PRELIMINARY OVERALL AREA DEVELOPMENT PLAN

MASTER PLAN

WESTLAKES

Re: Westlakes P.O.A.D.P. File No.: 83-10-57-66 Revised: 10/29/85

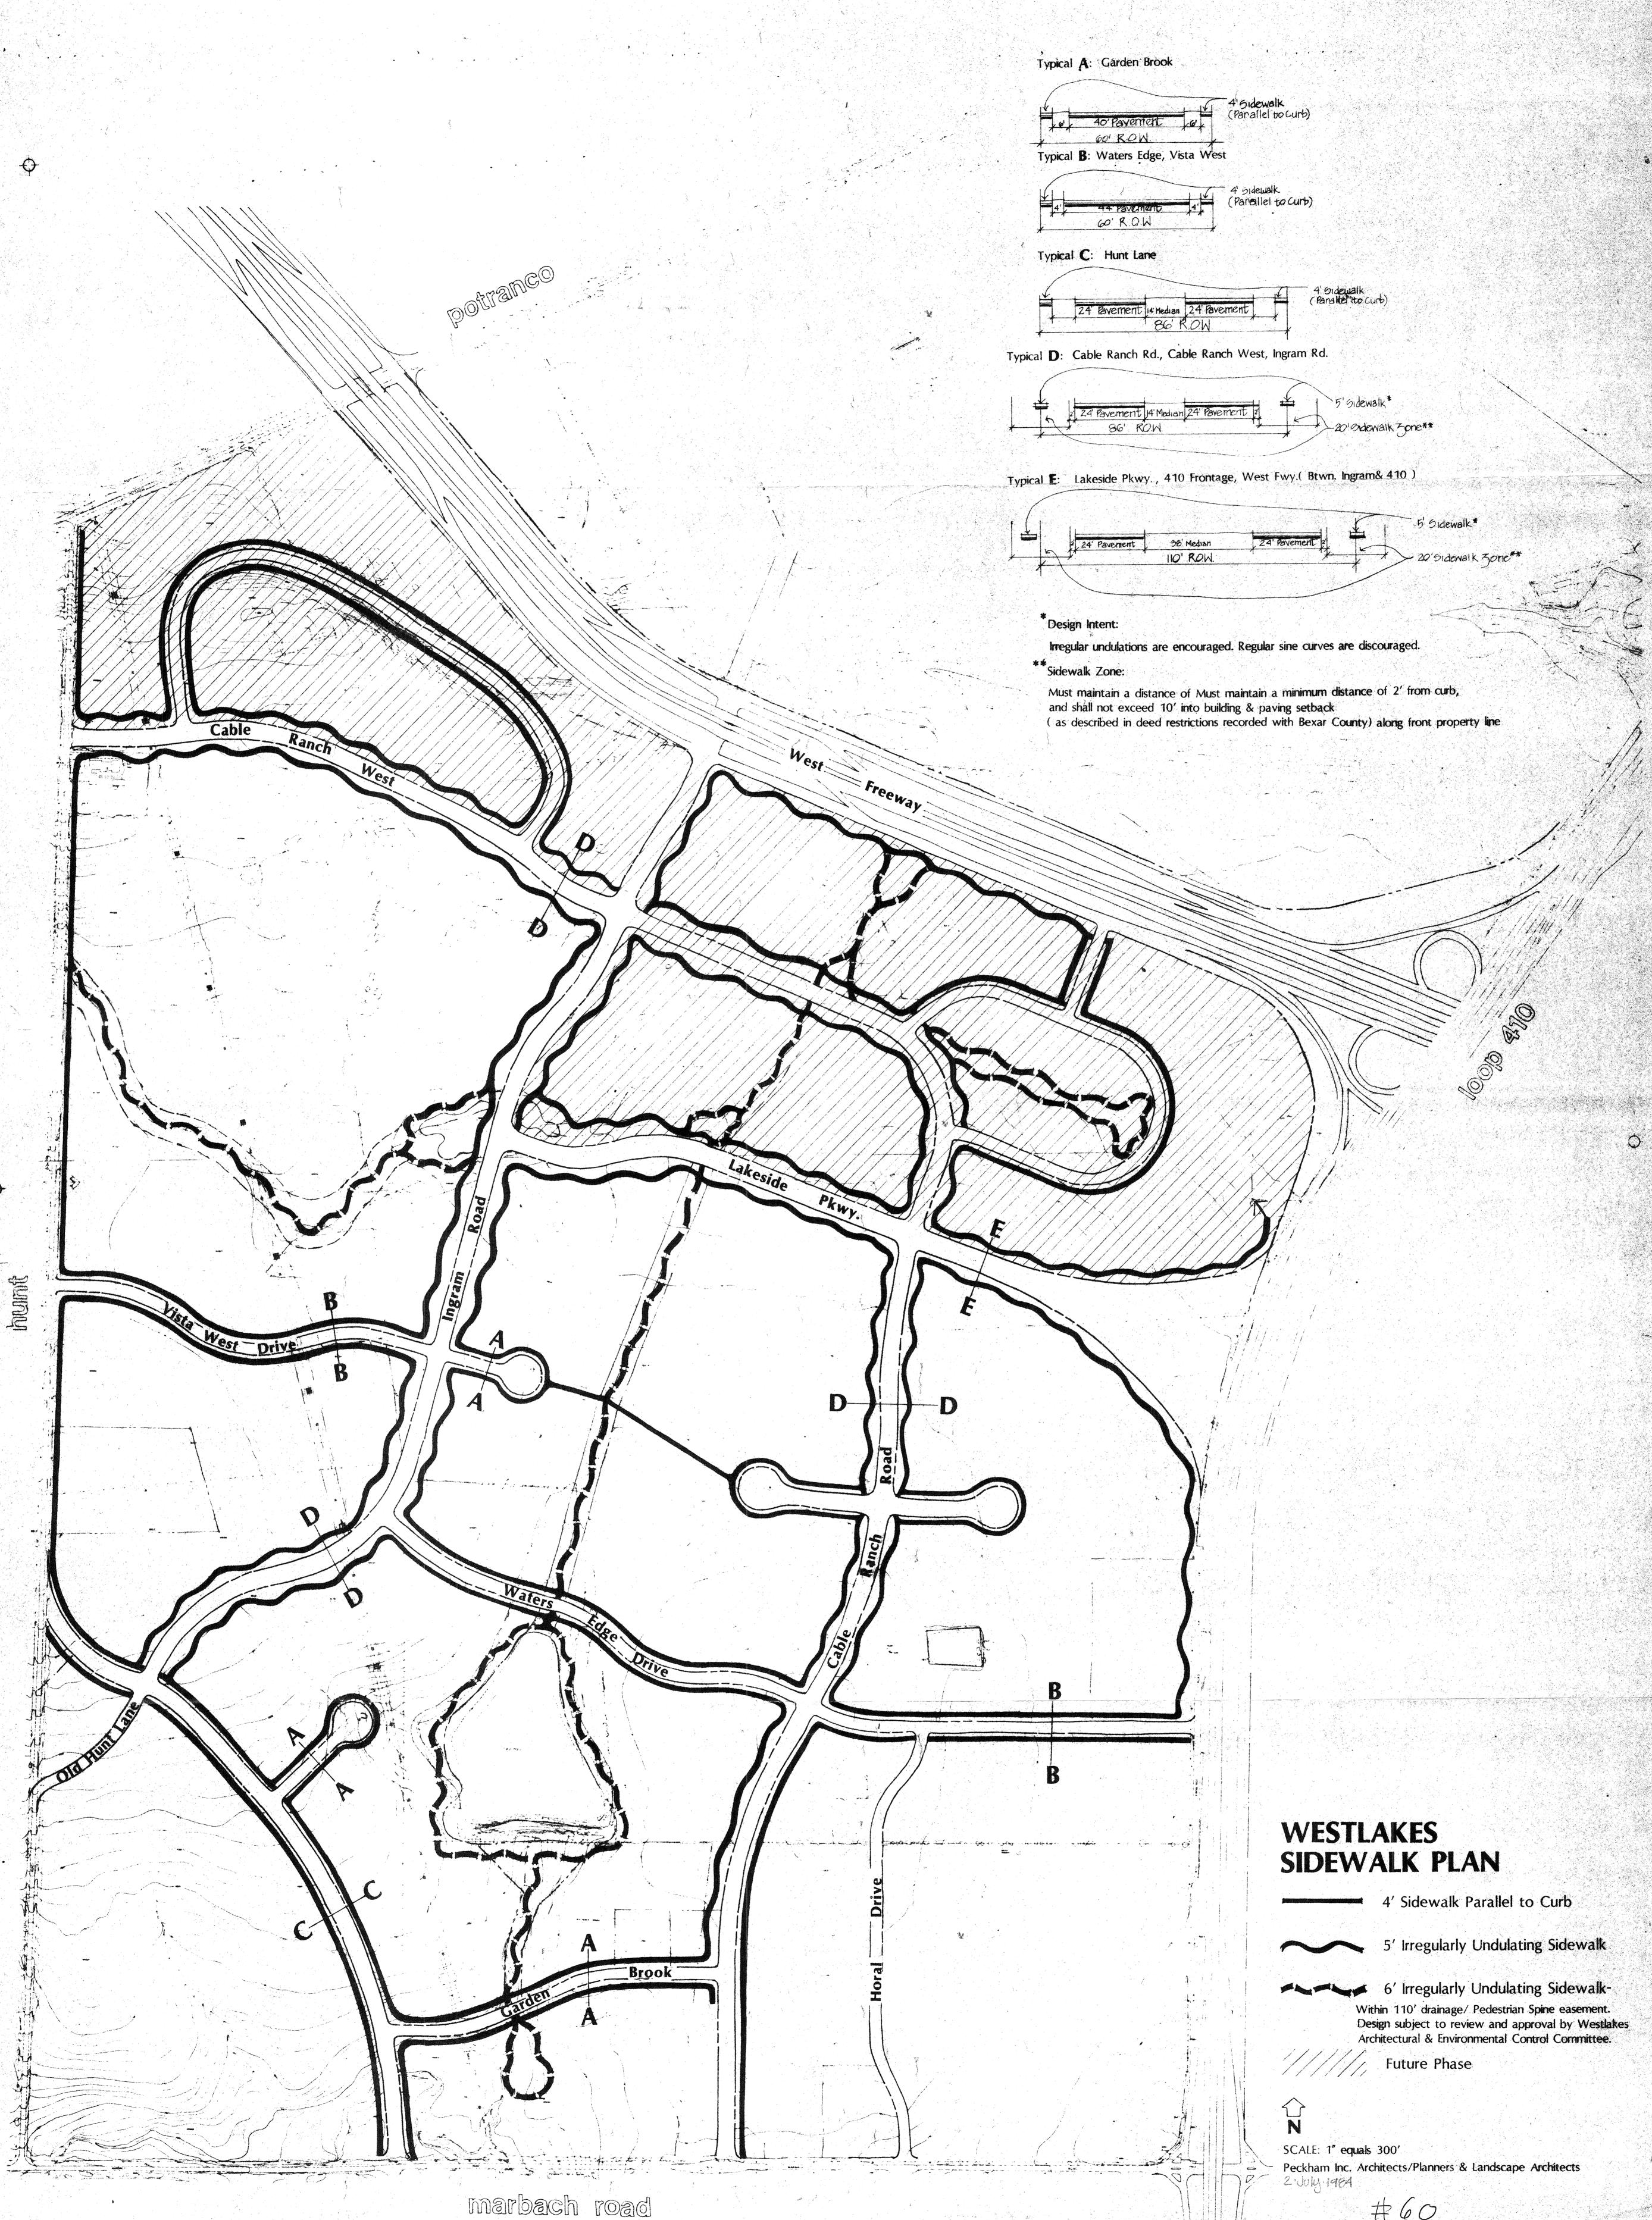
The P.O.A.D.P. committee has reviewed and accepted your latest revised plan for Westlakes which shows the addition of View West Drive. Please be advised that Potranco Road is designated as a primary arterial on the Major Thoroughfare Plan requiring 110' of right-of-way and that you must make provisions to provide the necessary dedication at the time of platting.

(x) Comments: Staff notes that Potranco Rd is on the Major Thoroughfare Plan as a Secondary Arterial type "A", 86' R.O.W. Any platting activity along said R.O.W. will require dedications for future street widening. Please coordinate your projects with the Highway Dept. for

Generally, our review concluded that said plan was in general compliance with Chapter 36 of the City Code. At that time, mention was made to the relationship of the designated major thoroughfares with your planned development. Staff cited the need for the necessary dedication for street widening along Hunt Lane, Marbach Road and Potranco Road in accordance with the Major Thoroughfare Plan.

Additionally, based on the information submitted to us by your office, we had indicated that the proposed new Hunt Lane connection appeared to comply with the Major Thoroughfare Plan. However, a representative for the developer of the developer of Heritage Farms Subdivision has since brought additional information to our (and your staffs) attention. More specifically, the Heritage Farms project provides for a west to east collector street (Heritage Farm Drive) which is planned to link with Old Hunt Lane. Said collector will connect with Old Hunt Lane approximately 2900' north of Marbach Road. As has been brought to our attention, the proposed Hunt Lane realignment and the planned collector street from Heritage Farms creates a less than desirable intersection for the City. In light of this and as we have mentioned in previous personal and telephone conversations with your staff, it is recommended that consideration be given to work with the adjacent property owner, Ray Ellison Homes, Inc., in an effort to relocate the northern portion of your new Hunt Lane connection to a more southern location and help to resolve this potential problem.
